**PROJECT: WEBSTER UNIVERSITY
INTERDISCIPLINARY
SCIENCE BUILDING
ST LOUIS, MO**

MANVILLE STANDARD DETAILS

SUBMITTAL ITEMS: Revised Roof Drawings

SUBMITTAL IDENTIFICATION SHEET

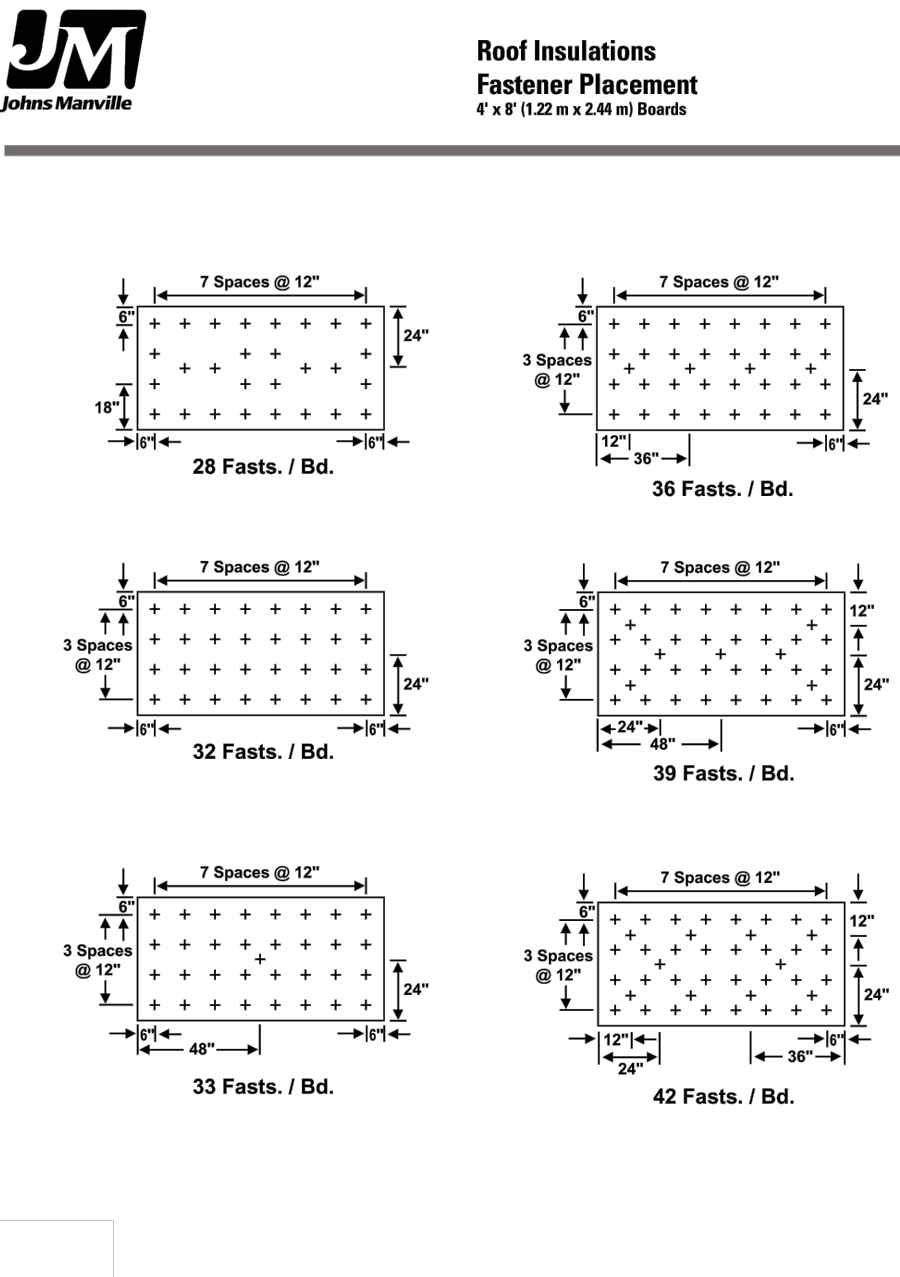
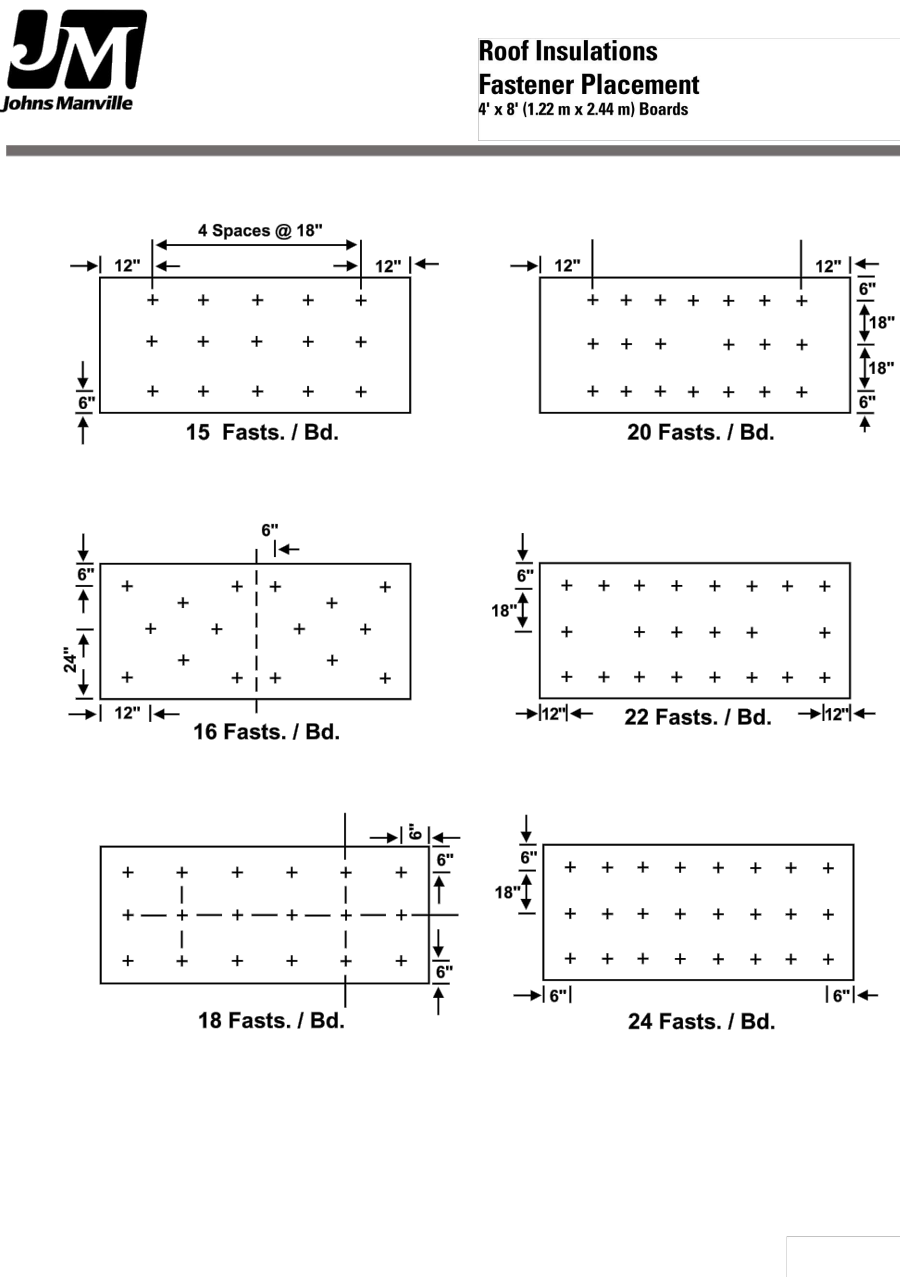
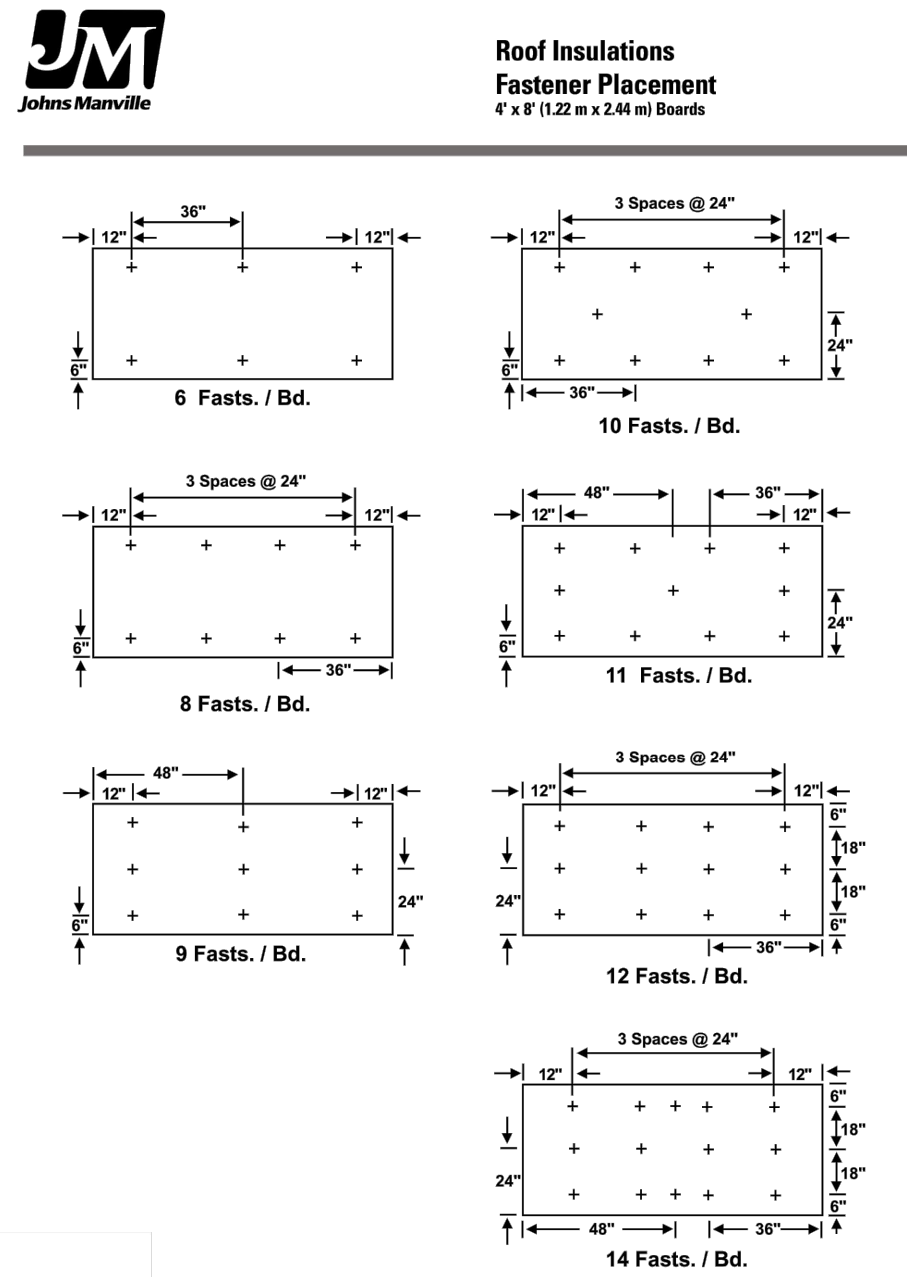
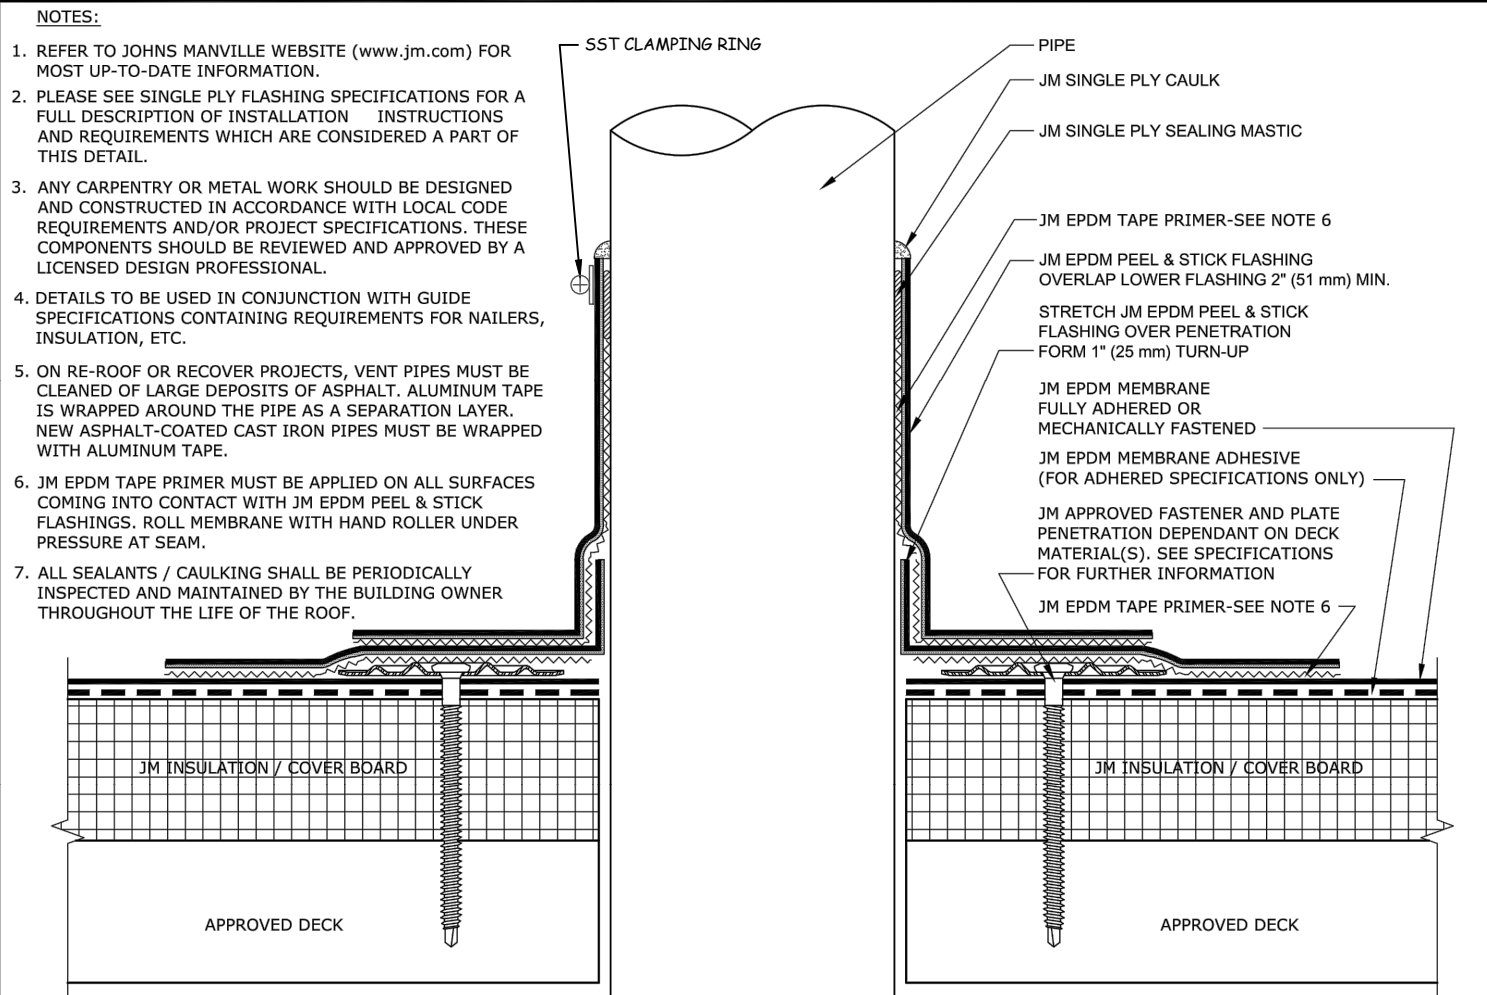
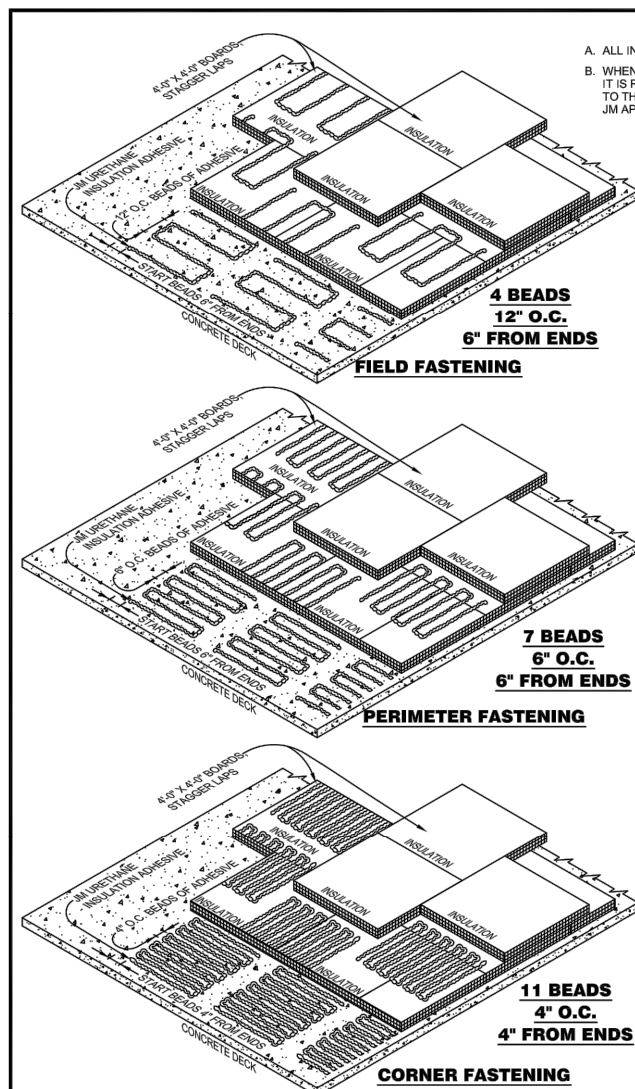
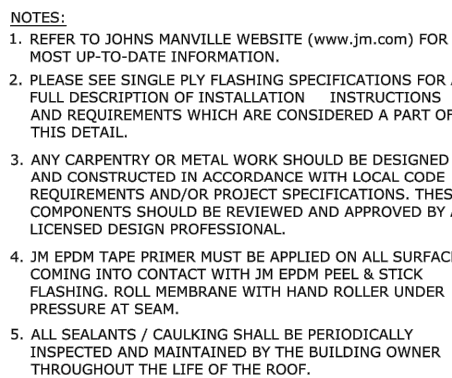
Manufacturer's standard details do not show that the contractor/installer are meeting detail requirements as shown in the contract documents. Manufacturer's standard details do not match existing conditions. Please provide details that show actual conditions and how roofing system will be installed to meet these conditions.
